PROPOSED COMMERCIAL DEVELOPMENT AT HOUGHTON MAIN

Walking, Cycling and Horse-Riding Assessment

Barnsley Council

09/03/2022

Figure 1.3 – Proposed ghost island priority access junction (RWO Consulting Engineers)

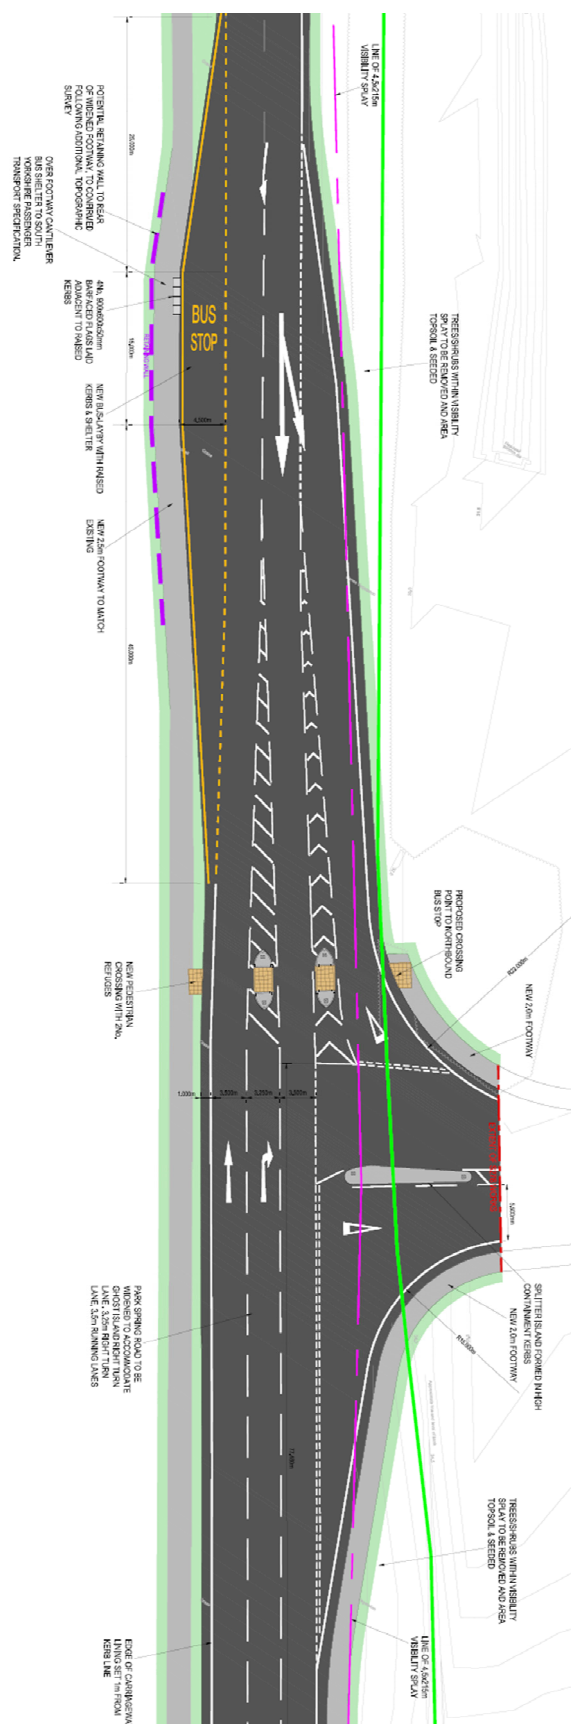
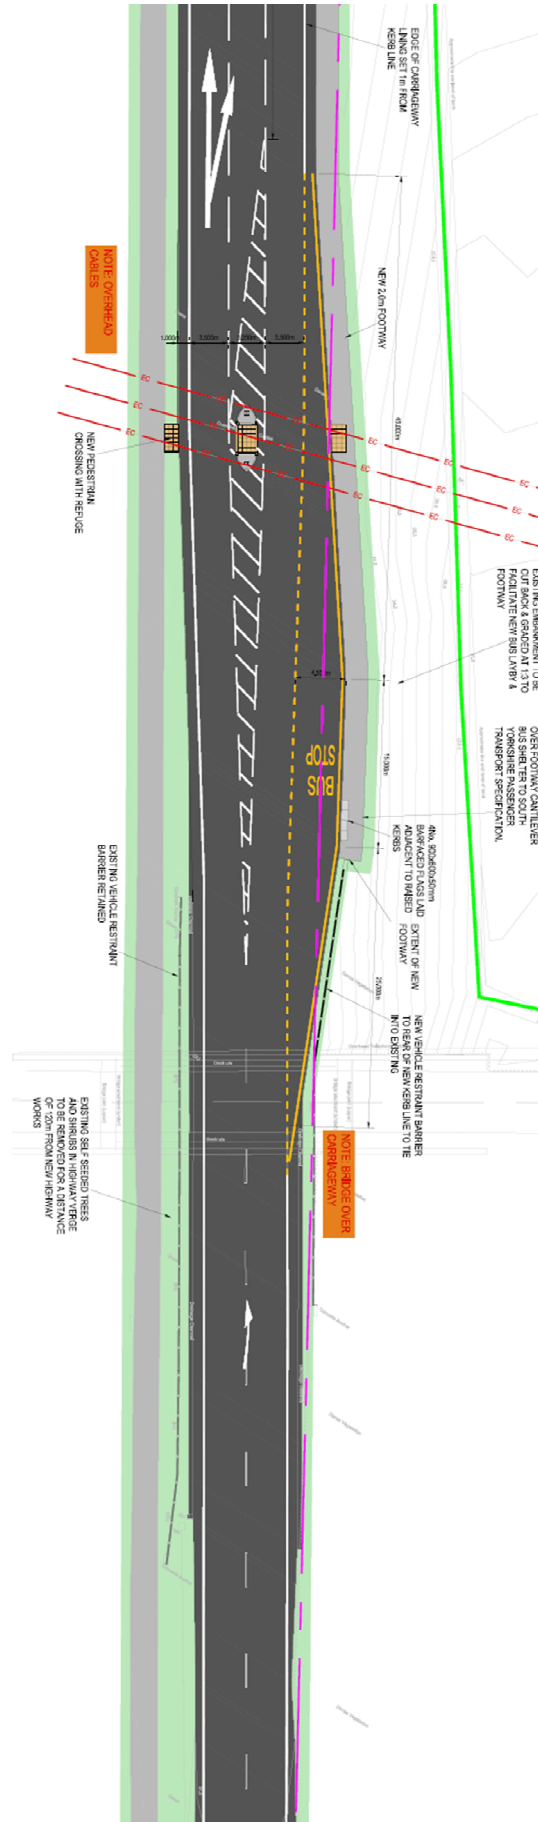
- 1.1.5 The access road, which is for employment land (industrial use, class E/B2 and B8) would be 7.3m wide, widening on its approach to the A6195 junction. The entry radius would be 22m and the exit radius would be 15m. Footways (2m wide) are to be provided on either side of the access junction to link into the existing footways on the southwestern side of A6195 Park Spring Road. Two bus stop laybys are to be incorporated into the access arrangements with the southeastbound bus stop provided some 100m south of the access and the northwestbound layby provided some 65m north of the access. Two uncontrolled pedestrian crossings (with refuge islands) are to be provided across the A6195
